**NOTICE OF TECHNICAL MODIFICATIONS
TO DEVELOPMENT AGREEMENT
FOR THE SILVER CREEK VILLAGE SPECIALLY PLANNED AREA**

SNYDERVILLE BASIN, SUMMIT COUNTY, UTAH

**EXHIBIT B1
TO NOTICE OF TECHNICAL MODIFICATIONS TO DEVELOPMENT AGREEMENT
FOR THE SILVER CREEK VILLAGE SPECIALLY PLANNED AREA**

**EXHIBIT G2
TO NOTICE OF TECHNICAL MODIFICATIONS TO DEVELOPMENT AGREEMENT
FOR THE SILVER CREEK VILLAGE SPECIALLY PLANNED AREA**

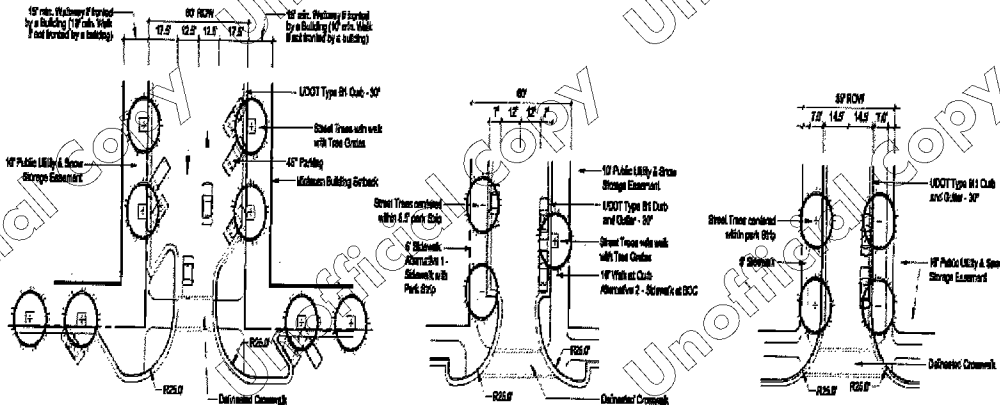
3. Technical Modifications Alley Standards. The County, by way of a Technical Modification to the DA, approves to modify and amend the standards for Alleys as follows:

a. The Alley's vertical profile shall be designed starting at the edge of the existing asphalt roadway (not the top back of the curb) with a maximum average allowable grade percentage of 5 percent (5%) for the initial fifty feet (50') of the Alley and thereafter designed to a maximum allowable grade percentage of ten percent (10%).

Alley Notes
 The Alley's vertical profile shall be designed starting at the edge of the existing asphalt roadway from the top back of the curb with a maximum average downward grade percentage of 5 percent (5%) to the full finished (FIF) of the Alley and thereafter designed for maximum allowable grade percentage of ten percent (10%).
